# CITY OF ALBUQUERQUE

**RE: 8500 Glendale Ave. NE**  
**Grading and Drainage Plan**  
**Engineer's Stamp Date: 05/28/19**  
**Hydrology File: B20D067**

## DRAINAGE AND TRANSPORTATION INFORMATION SHEET (REV 11/2018)

8500 Glendale  
Public Infrastructure

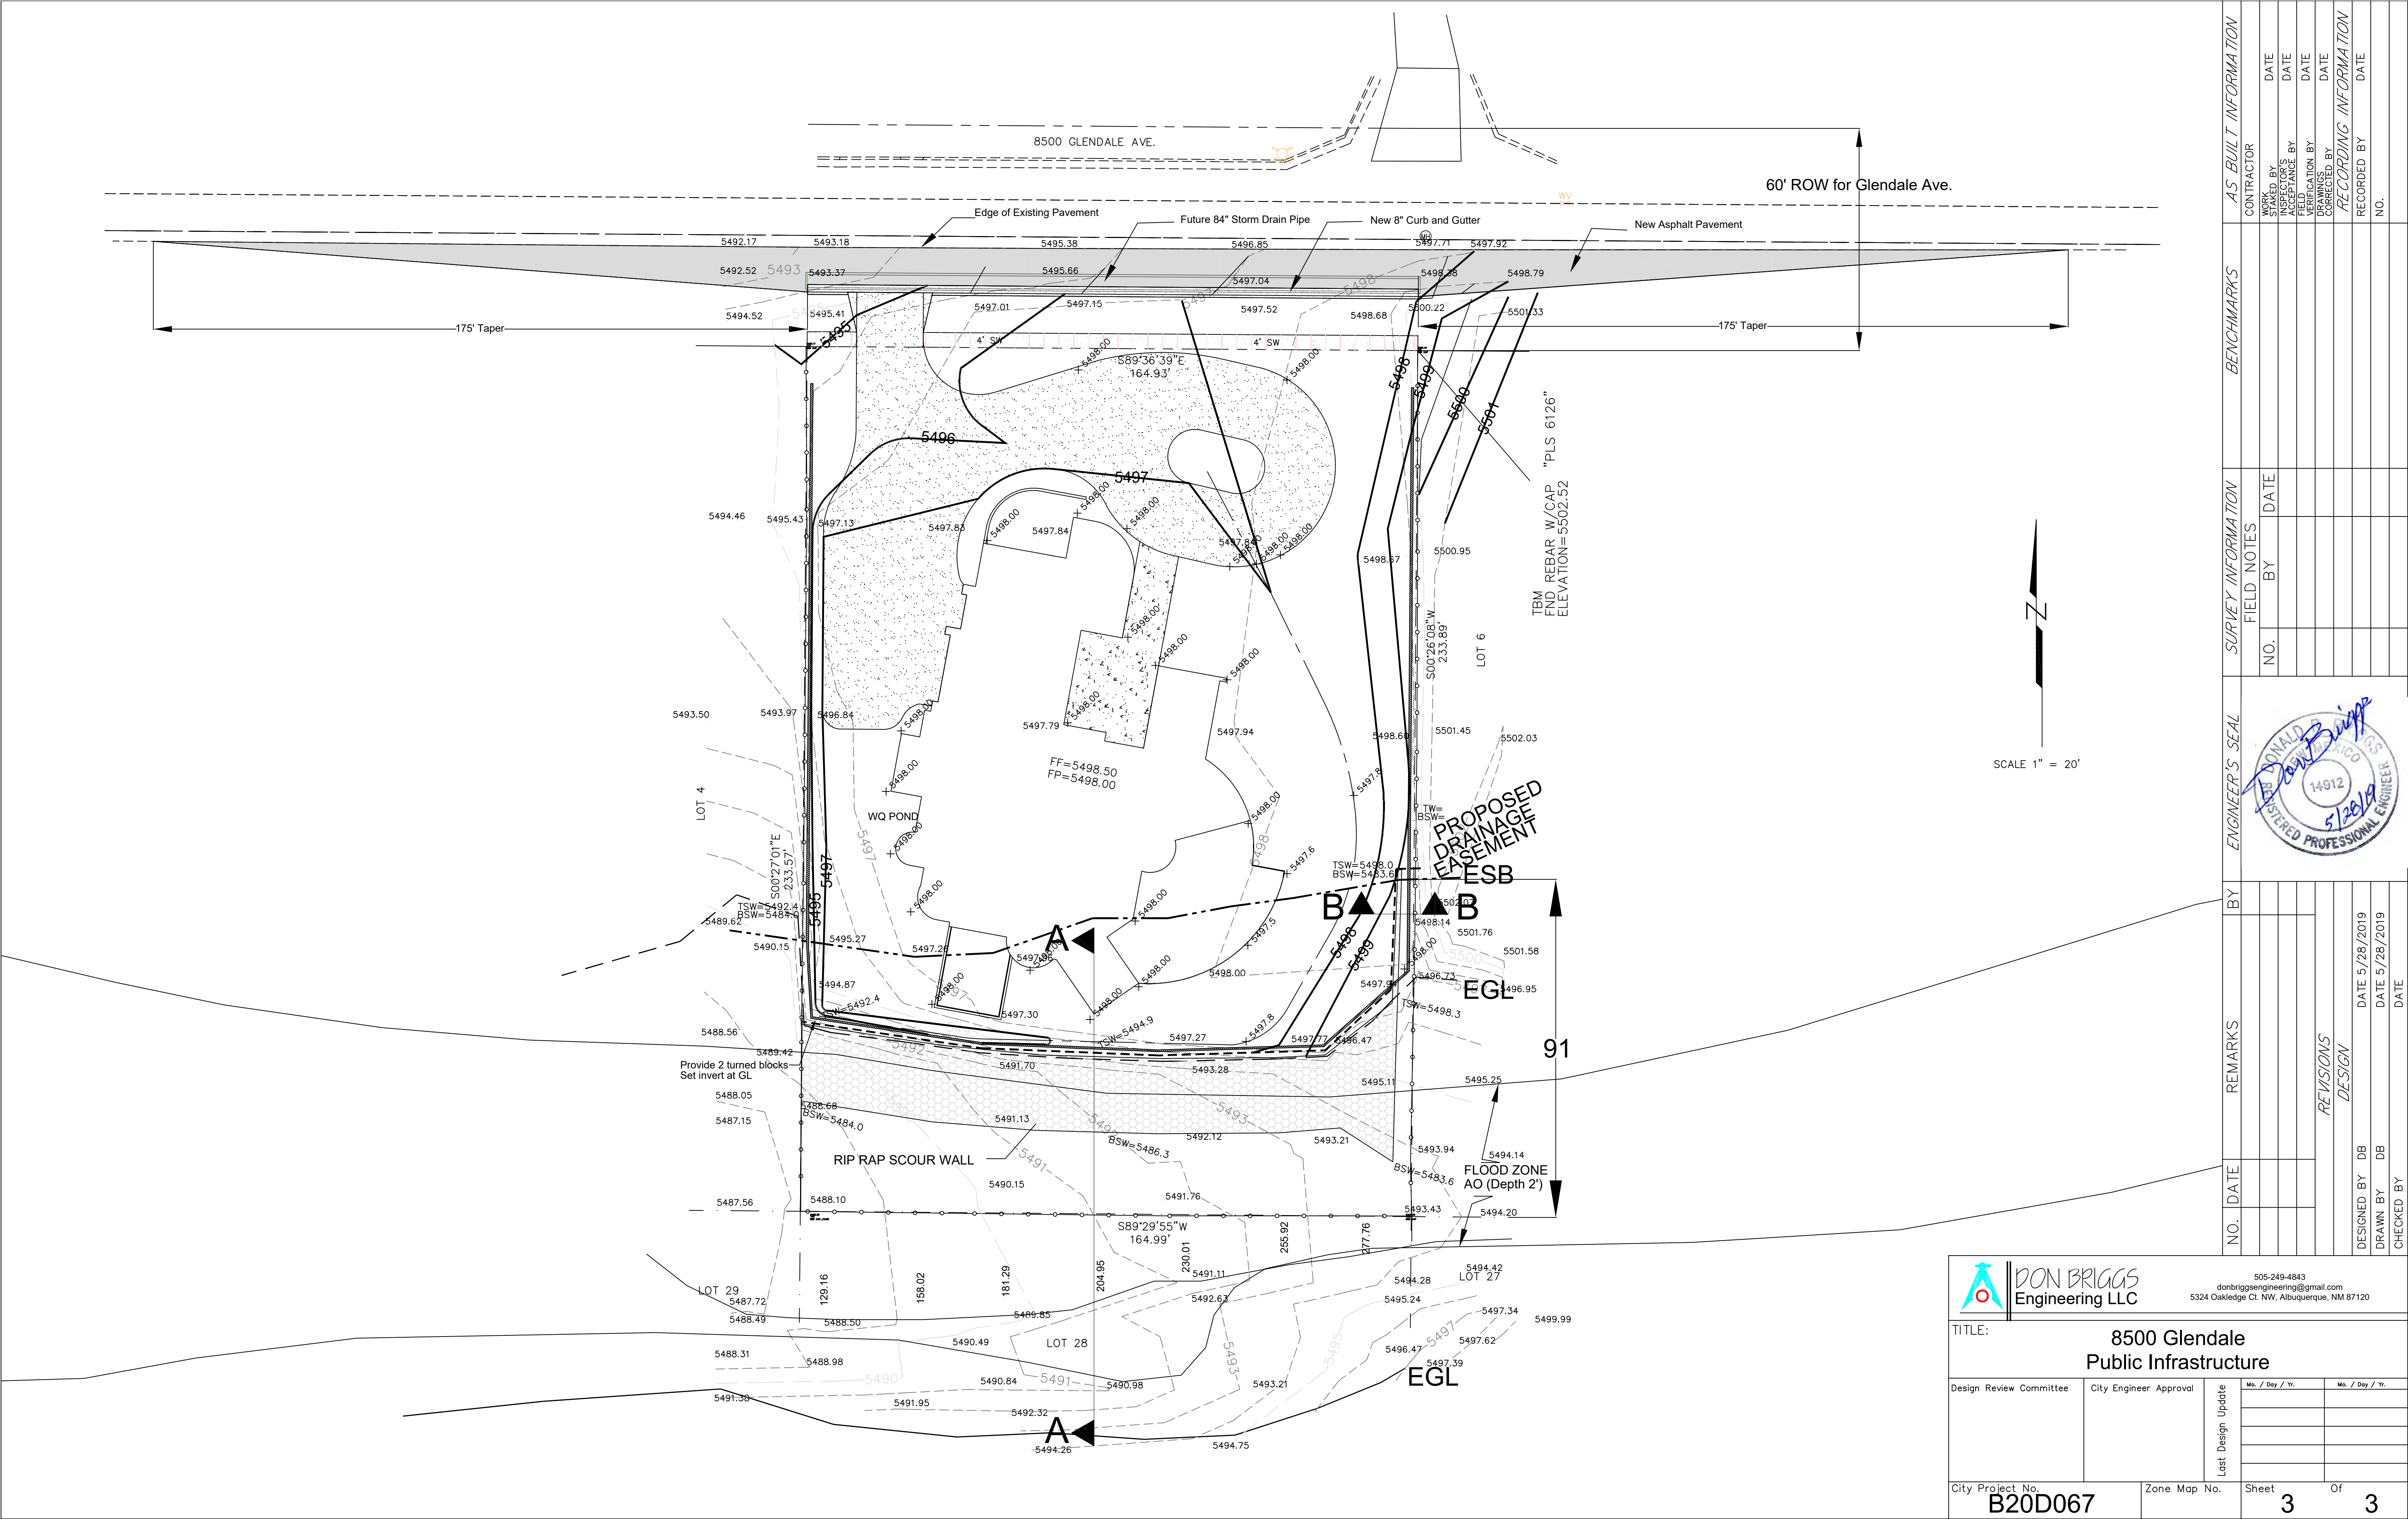
11. Please clarify what is being proposed within the R.O.W. There are multiple lines without any labels. Per the IDO § 6-4(Q), the property owner of the property is responsible for building the adjacent half of Glendale Ave to include curb & gutter, sidewalk, and 84" storm sewer per the North Albuquerque Area Master Drainage Plan. The plan will have to go to the DRB for approval of the Infrastructure List which will have to be financially guaranteed. *A note regarding public infrastructure requirements has been added to the plan and an additional sheet prepared illustrating the required infrastructure improvements.*
